Product Change Notice

ECR No	ECR_25000407	Date	Mar 03 th , 2026
Customer			
Model Name	Original		
	New		
Cause of Change	Improve the issue where LCM cannot be shut down when the system enters standby mode.		
Content of Modification	- PCB design change - SPEC Added User Guide - Electric parameter : No changes		
Type of Acting	☒ Running Change ☐ Cut in ☐ 2nd source Approval ☐ Others: _____		
Powertip Signature	Action	Signature	Date
	Prepared by	Yuan Chang	Mar 03 th , 2026
	Checked by	Rex Liao	Mar 03 th , 2026
Appendix Documents	-		
For customer			
Signature	Action	Signature	Date
Customer's Comment

Appendix: Appearance

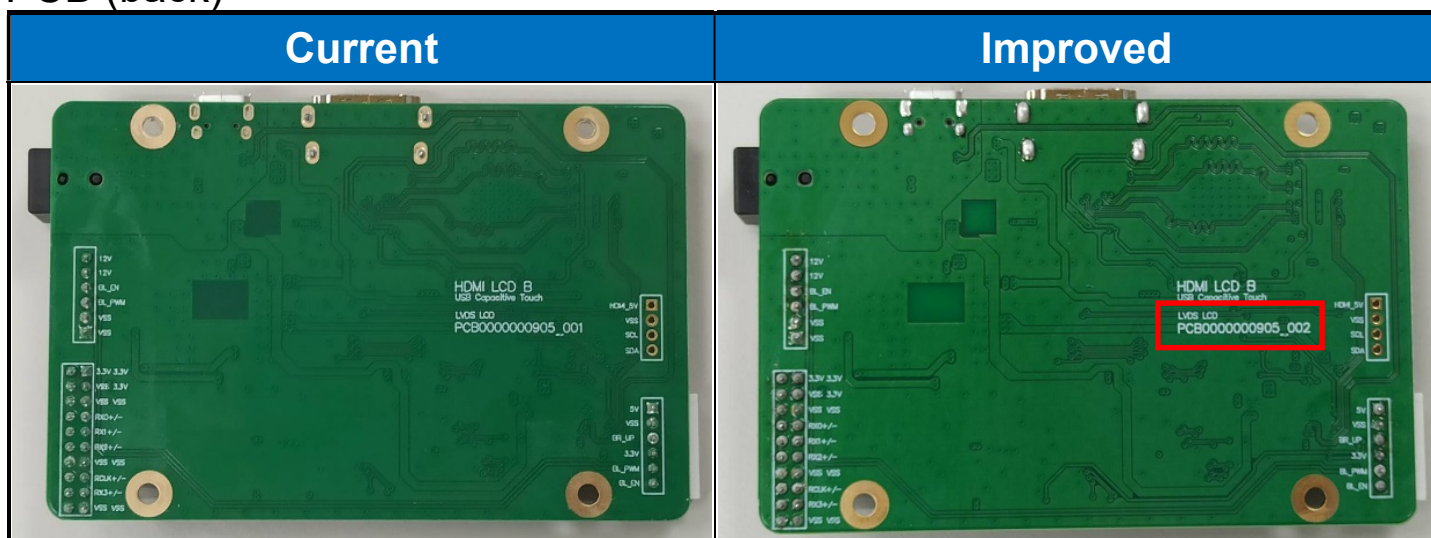
Comparison results: The red-marked parts are different.
